Re: Nine Mile Point Unit 2
Docket No. 50-410

Interim Report for a Problem
Concerning HEA Relays

SUBJECT: SERVICE ADVICE 721PSM-175.1 HEA RELAY MISOPERATION

Figure 1

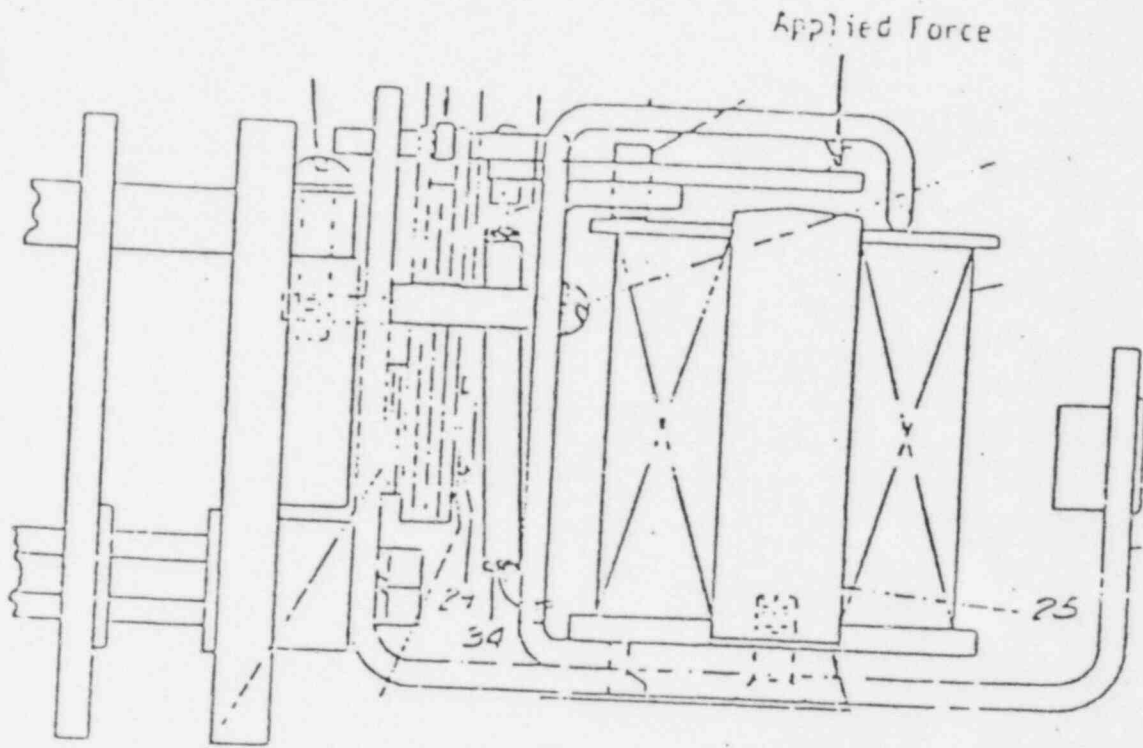
We recommend that all HEA relays manufactured between September 1980 and August 1983, corresponding to date codes KS, LS, MS, AT through MT, AU through MU, and AW through LW, should be checked to determine the force, applied at the armature, to trip the relay. This force should be checked by applying a measurable force perpendicular to the armature at the armature rivet above the pole piece as shown in Figure 1. (Attached)

Any relay requiring a force less than 500 grams or 1.1 pounds should be considered out of specification.

It is recommended that any HEA relay, with the above date codes, that does not meet the above specification be replaced.
